ADDENDUM NO. 2:

| FHWA REGION NO. | STATE | PROJECT NO. | YEAR | SHEET NO. | TOTAL SHEETS |
|-----------------|--------|-----------------|------|-----------|--------------|
| 7 | KANSAS | 54-87 K-6657-01 | 2002 | 632 | 1122 |

RECORD DRAWING

| No. | Revisions | By | Date |
|--|-----------|------------|-------------|
| GENERAL NOTES & LEGEND | | | |

DUCTBANK DETAIL
 NO SCALE

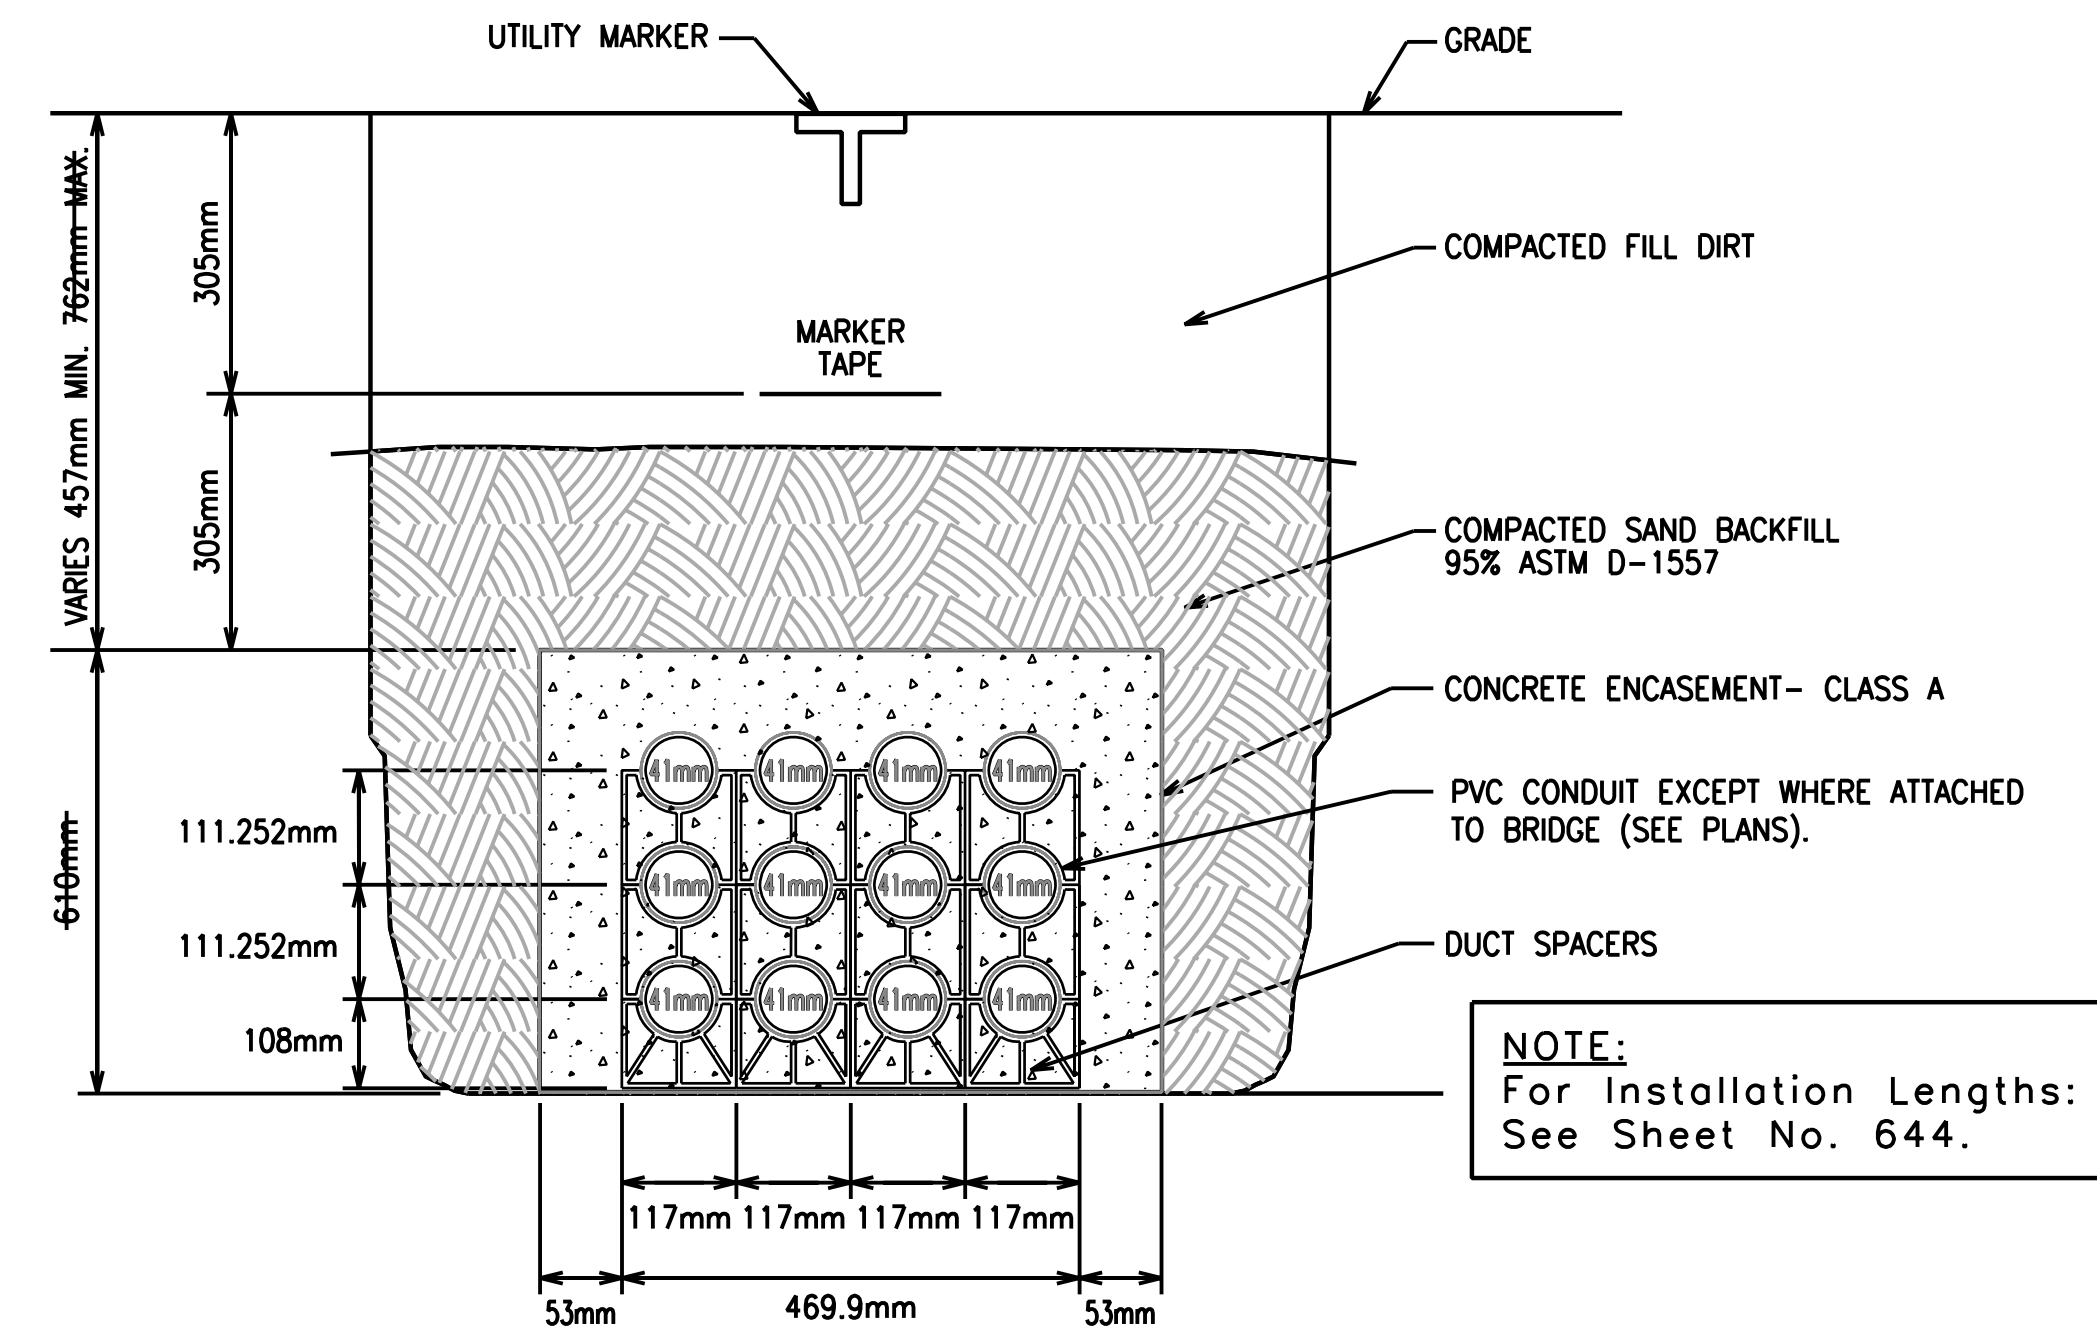
- Sheet 632
- Ductbank Detail: Change the overall height of the concrete encasement from 610 mm to 440 mm. It is acceptable to use excavated trench walls to form the ductbank where soil conditions permit rather than the formed ductbank shown. Delete the maximum depth of 762 mm from the top of ductbank to the top of the trench. Excavatable flowable fill will only be required under pavement where the depth of backfill from top of the ductbank to the top of subgrade exceeds 600 mm.
